RE: VGT Phase I SUP Application #2009-01P

Re: Village at Grand Traverse – Phase 1 Site Plan – 3rd Review
OHM Job No. 0237-09-0030

VILLAGE OF GRAND TRAVERSE, L.L.C.
THE VILLAGE AT GRAND TRAVERSE PHASE I
 OVERALL PHASE I SITE PLAN - P.C. PH I RECOMMENDATION SUBMISSION
 SECTION 2, TOWN 27 NORTH, RANGE 10 WEST
 ACME TOWNSHIP, GRAND TRAVERSE COUNTY, MICHIGAN

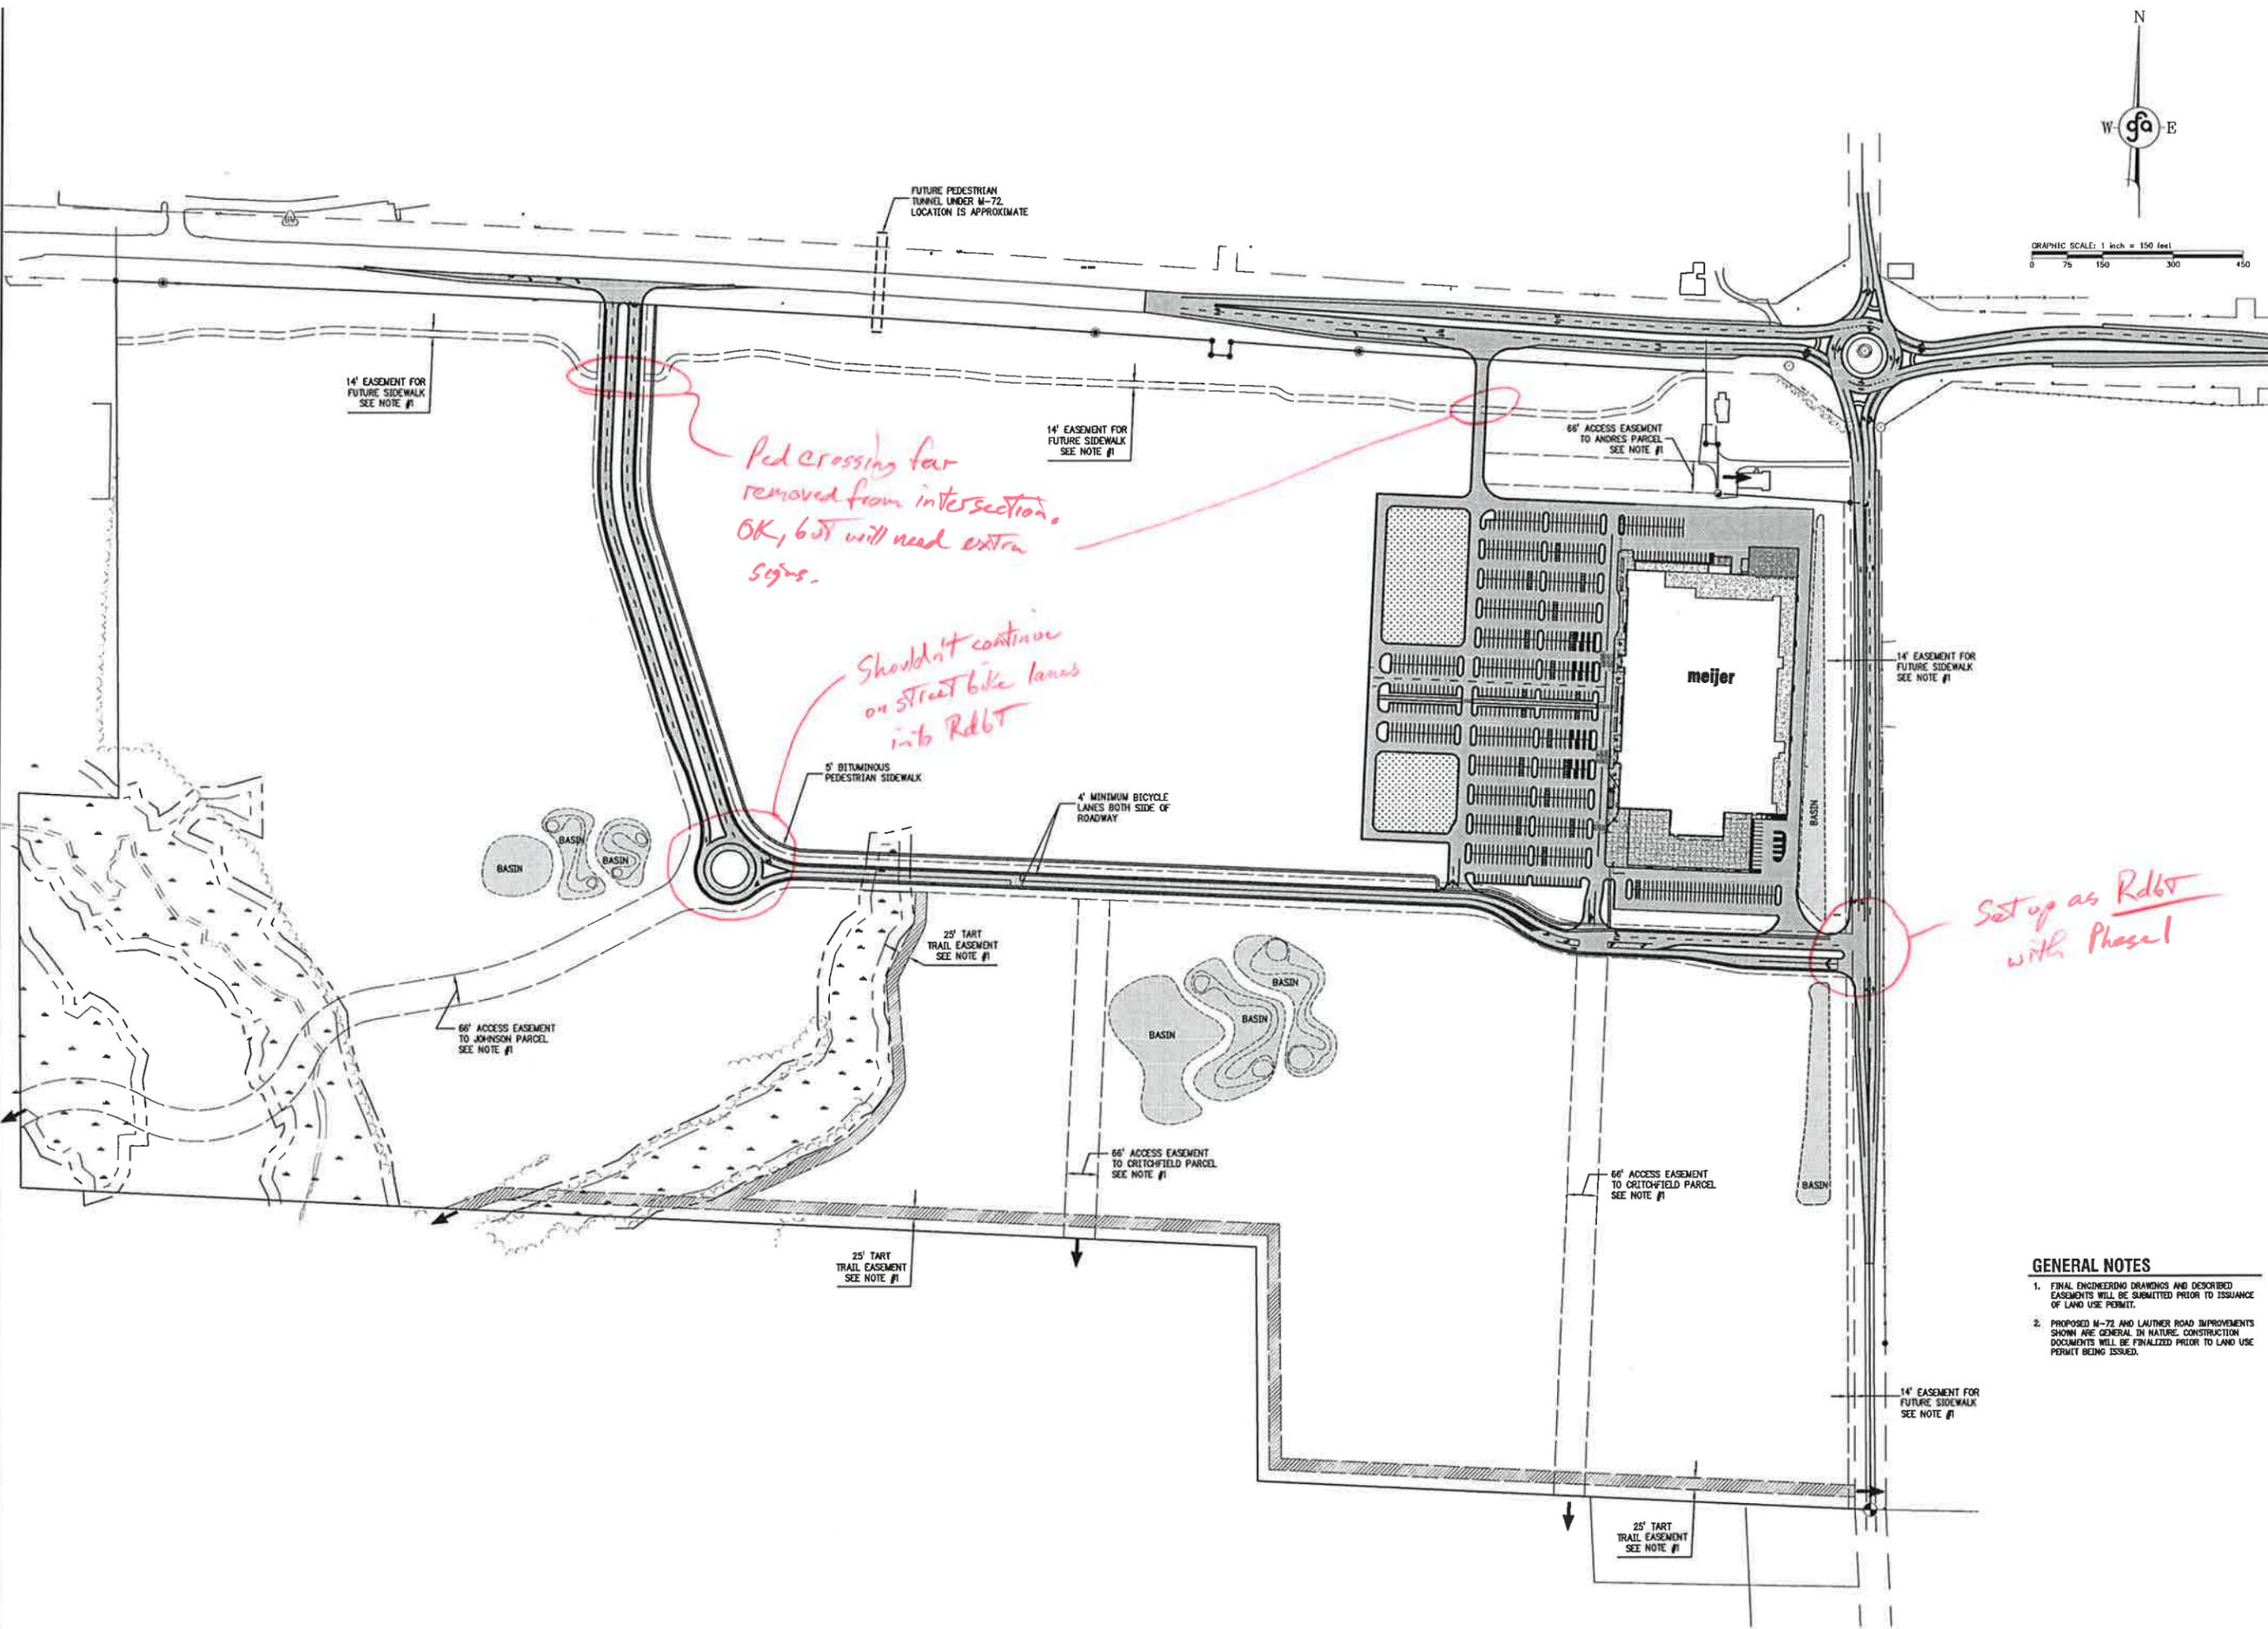
- ❖ The improvements to Lautner Rd should extend at this time to the southern property line of the full development site.
- ❖ We recommend that the proposed intersection of Lautner Rd and Drive No. 5 be constructed at this time as a single lane roundabout.

- ❖ While acknowledging the provision of on-street bike lanes, acceptable roundabout design is to terminate such bike lanes prior to entry into the roundabout, provide a ramp for timid cyclists to ride up onto the adjacent sidewalk and a ramp back to the roadway on the departure side of the roundabout. Under no circumstances are bike lanes to be provided within the circulating roadway of a roundabout.

- ❖ The proposed easement along M-72 for future sidewalk will result in pedestrian crossings of various drives far removed from their intersection with M-72. While unconventional, this will be acceptable if there are sufficient traffic signage and pavement markings for these crossing points.

- ❖ Need to pre-plan the location of all pedestrian crossings, to ensure ADA-compliant design. Recommend providing all curb drops at this time for future handicap ramps.

VILLAGE AT GRAND TRAVERSE, L.L.C.
THE VILLAGE AT GRAND TRAVERSE PHASE I
PHASE I WATER AND SEWER PLAN - P.C. PH I RECOMMENDATION SUBMISSION
SECTION 2, TOWN 27 NORTH, RANGE 10 WEST
ACME TOWNSHIP, GRAND TRAVERSE COUNTY, MICHIGAN

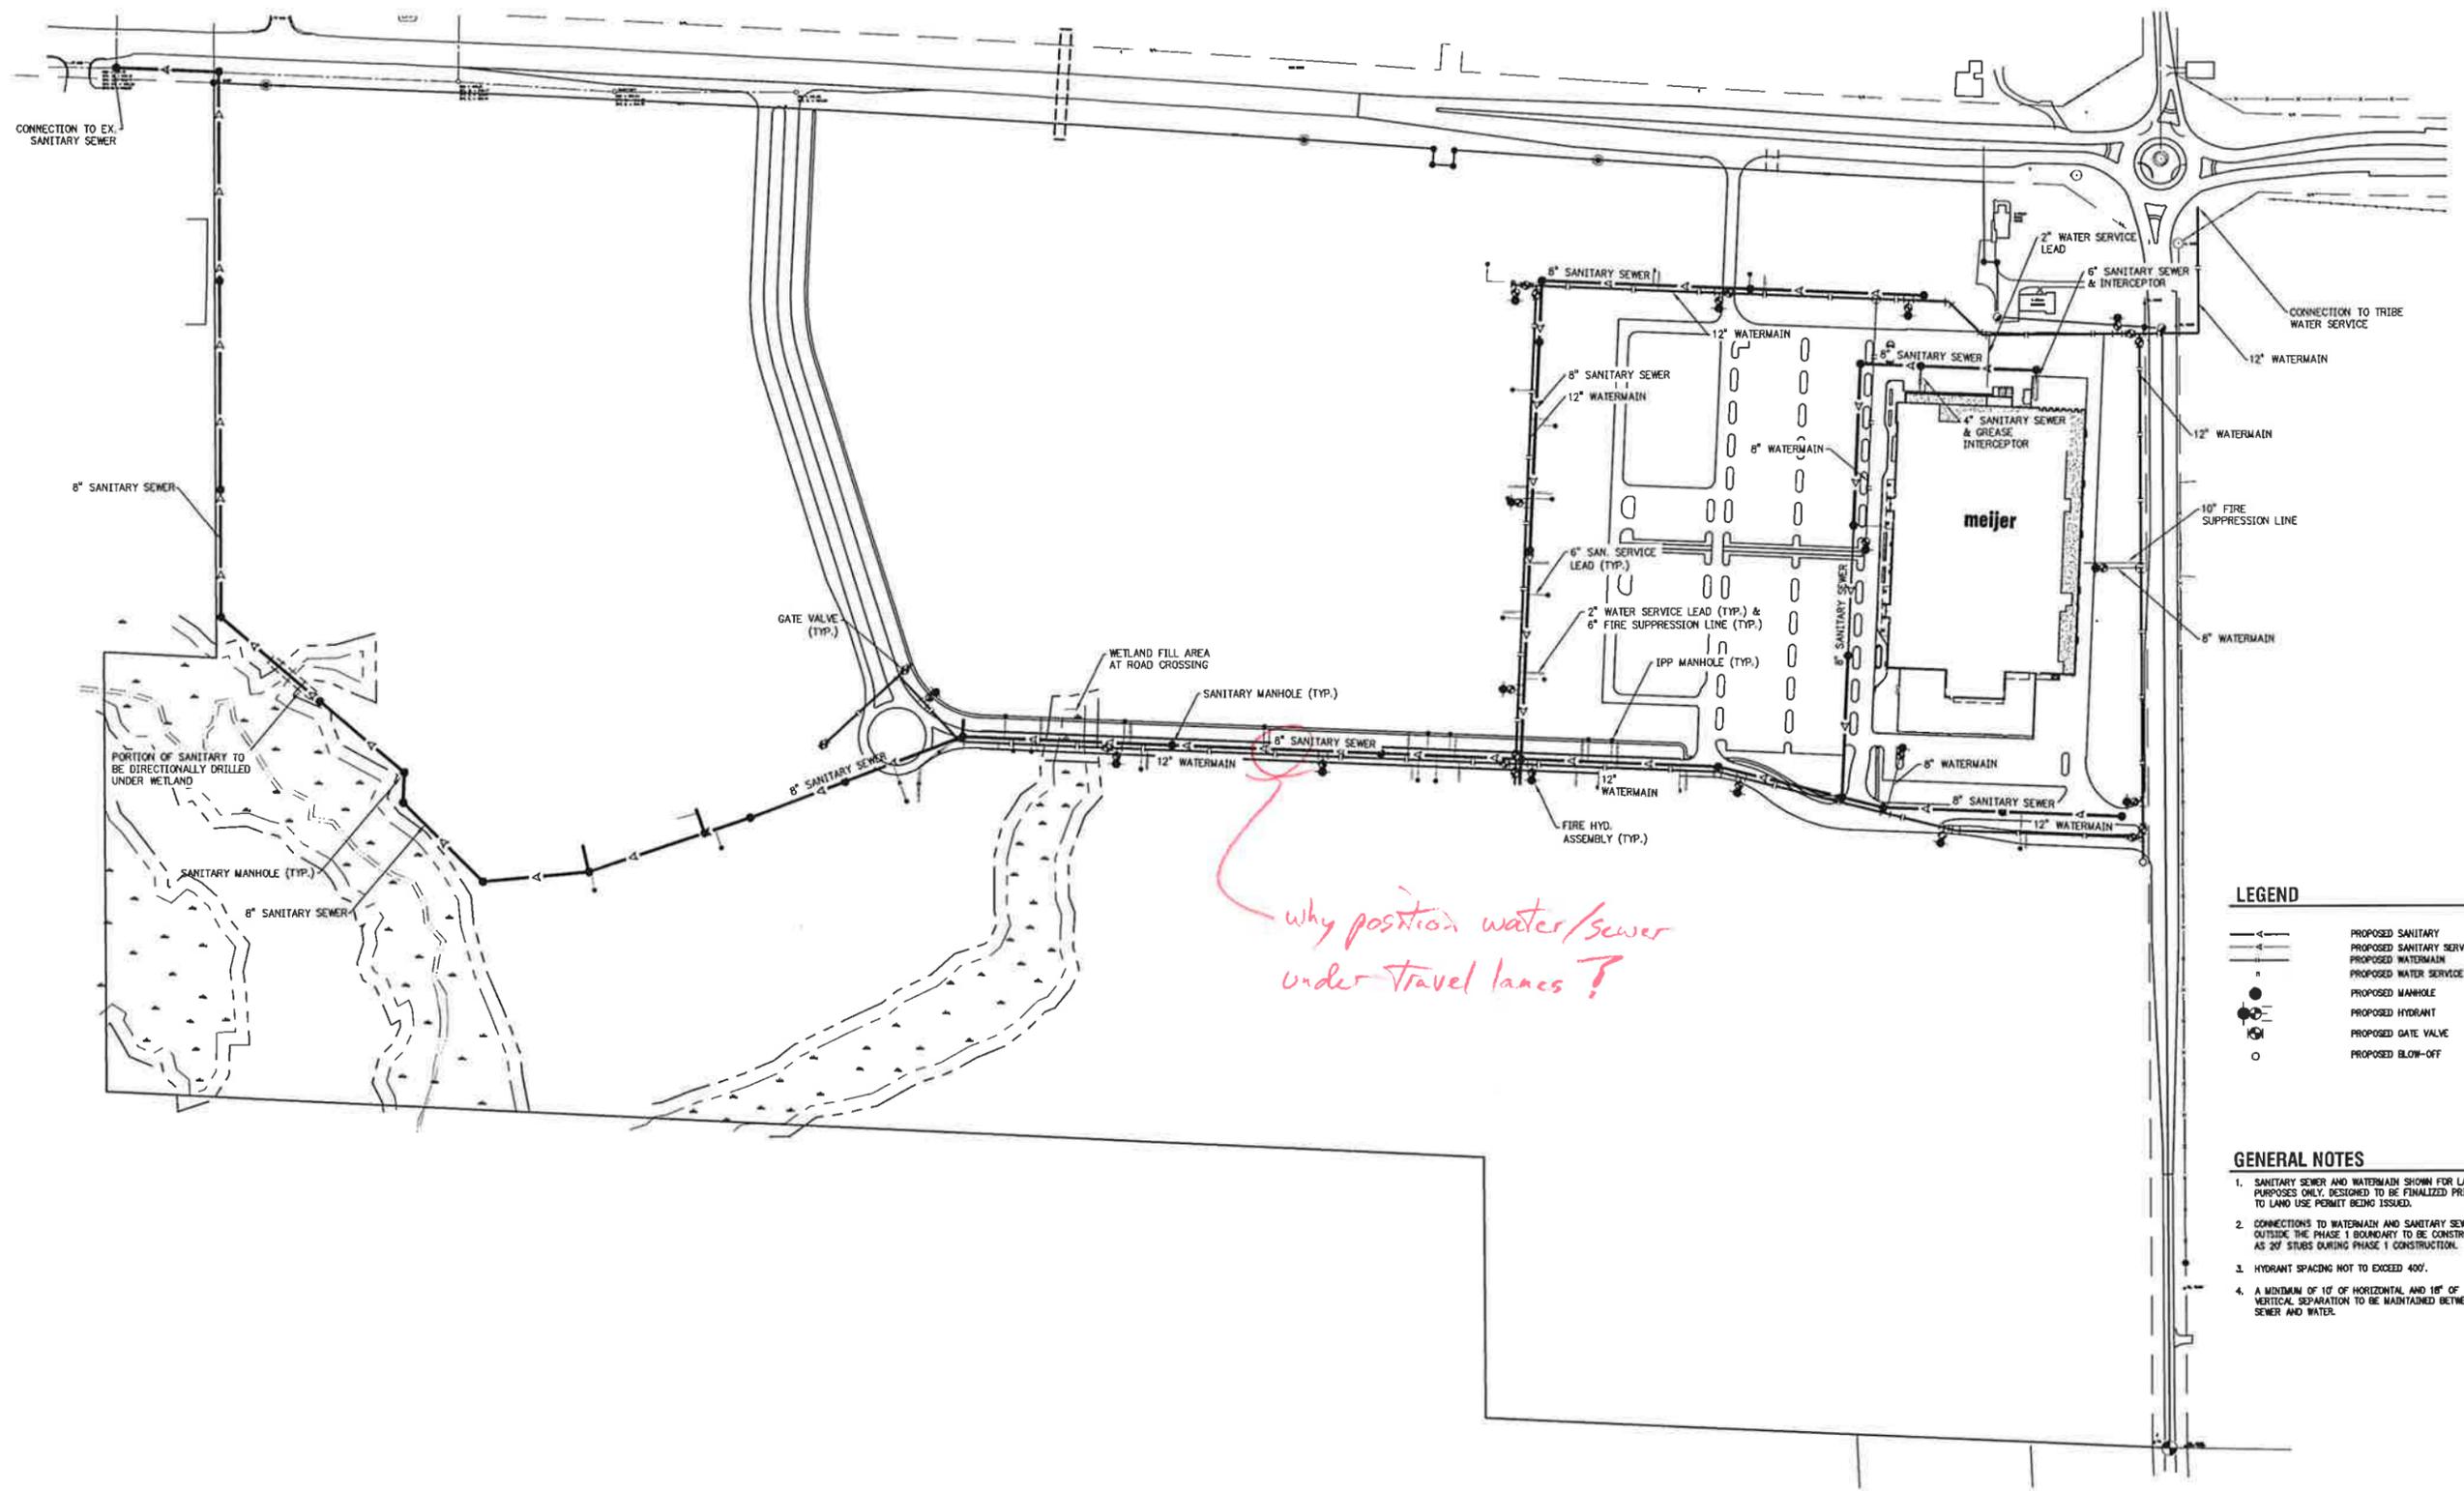
- ❖ From the design details of the Main Corridor, we see that underground utilities of water & sanitary sewer are being placed under the pavement. These should not be so located. Tapping the mains for building leads or any repairs will guarantee significant traffic disruptions. The

plans need to shift these mains to the outside of travel lanes.

why position water/sewer under travel lanes?

THE VILLAGE AT GRAND TRAVERSE, L.L.C.
 THE VILLAGE AT GRAND TRAVERSE PHASE I
 PHASE I MEIJER STORE FRONT - P.C. PH I RECOMMENDATION SUBMISSION
 SECTION 2, TOWN 27 NORTH, RANGE 10 WEST
 ACME TOWNSHIP, GRAND TRAVERSE COUNTY, MICHIGAN

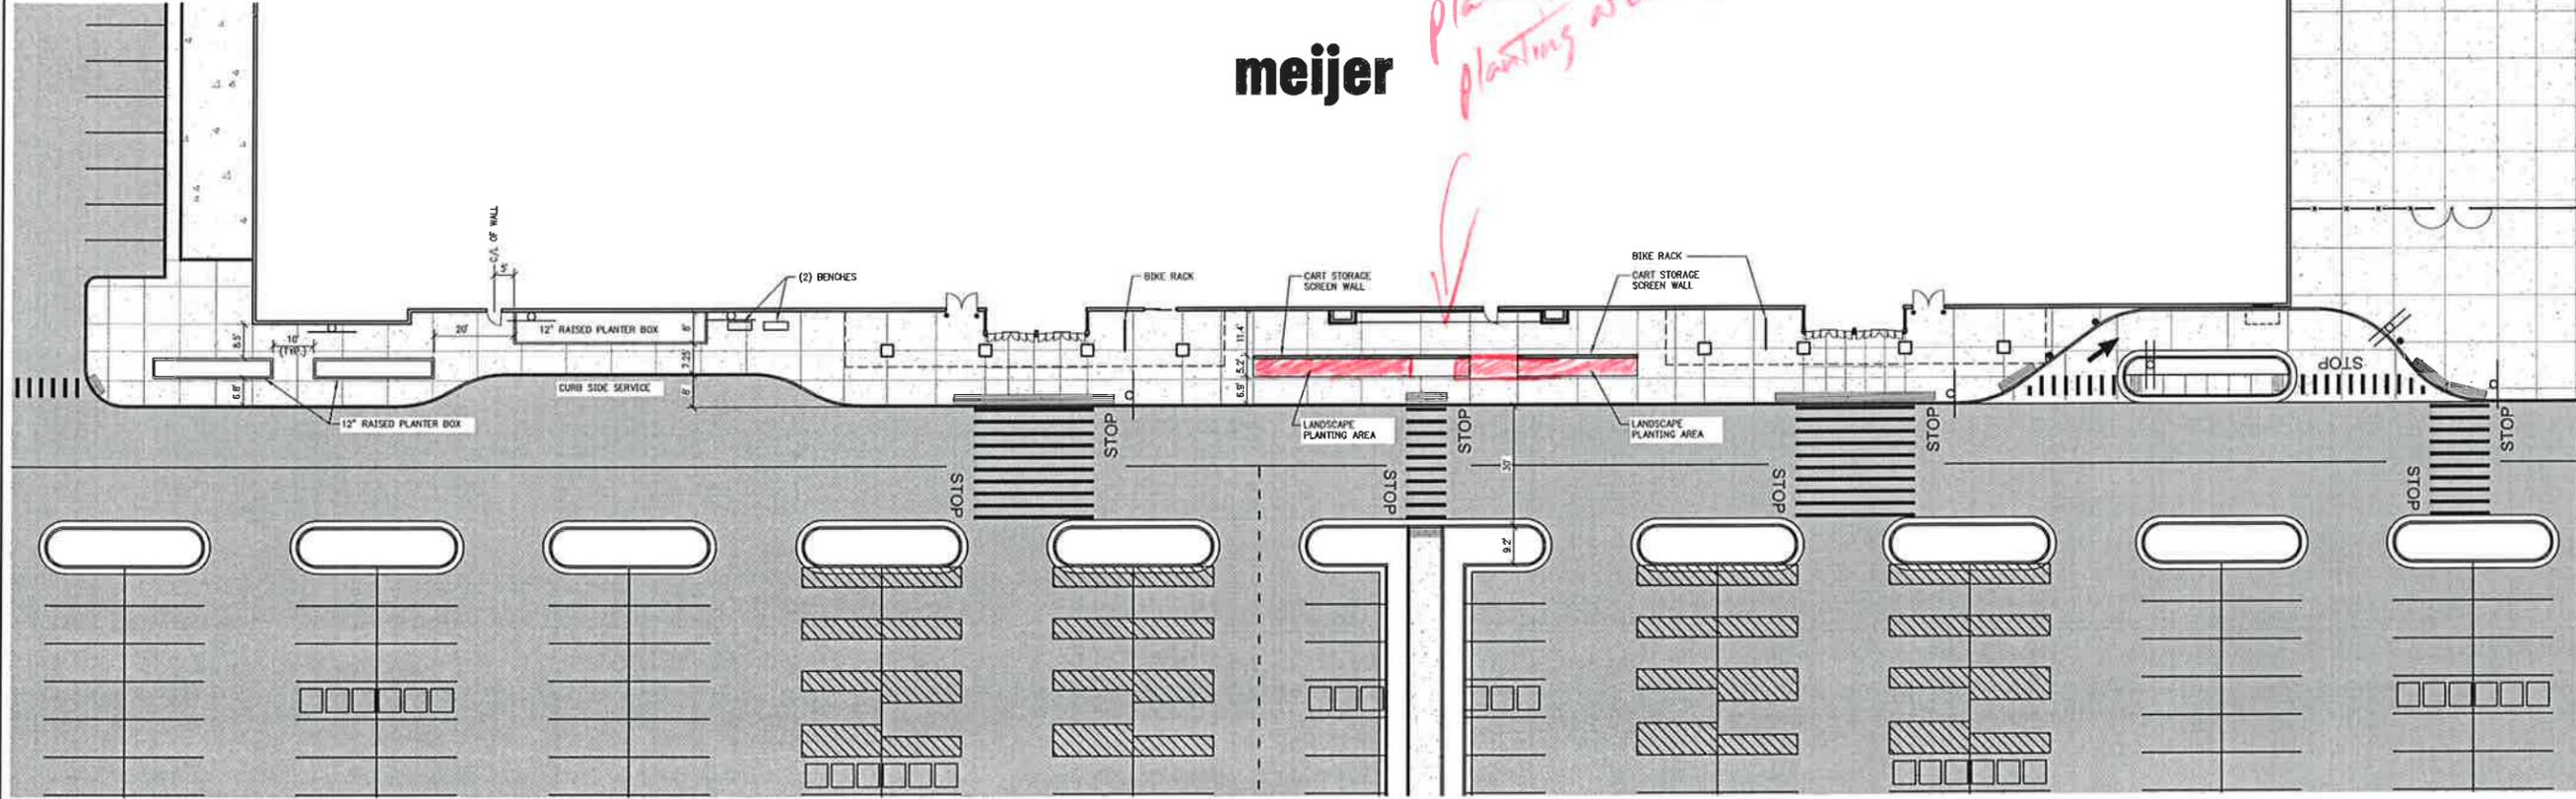
- ▼ Place the gap between the planned landscape planting areas so that it is opposite the pedestrian crossing of the storefront circulation aisle.
- ▼ Add notes to indicate what traffic signs are being proposed for the pharmacy drive up window.
